IN THE UNITED STATES PATENT AND TRADEMARK OFFICE

For: Voice-Activated Control for Electrical Device

DETAILED ACTION

FIG. 2

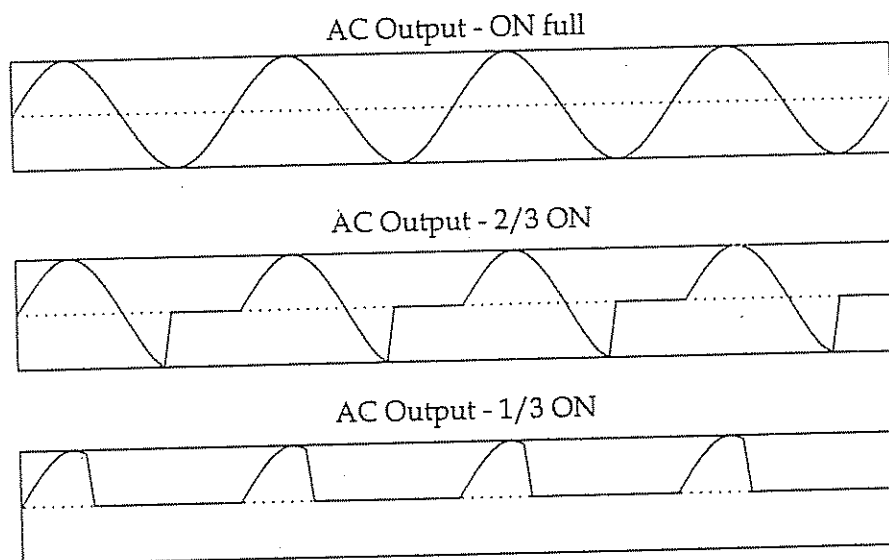
2. Figure 2 should be designated by a legend such as --Prior Art-- because only that which is old is illustrated. See MPEP § 608.02(g).

FIG. 8

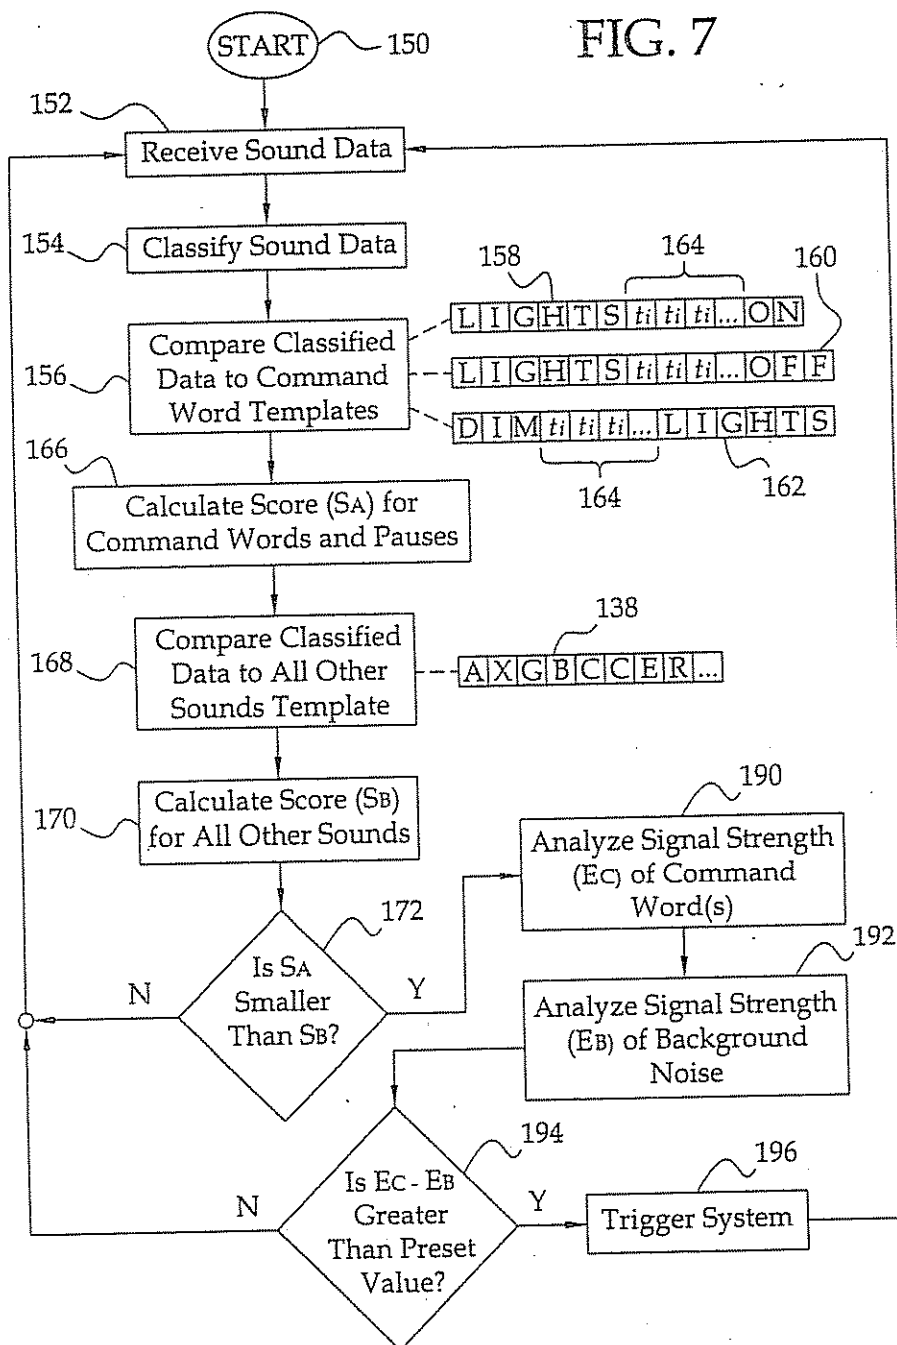
3. The drawings are objected to as failing to comply with 37 CFR 1.84(p)(5) because they include the following reference sign(s) not mentioned in the description:

- ° The term "Sample" is not used in conjunction with "Threshold" in the specification as it appears in item 206 of figure 8.
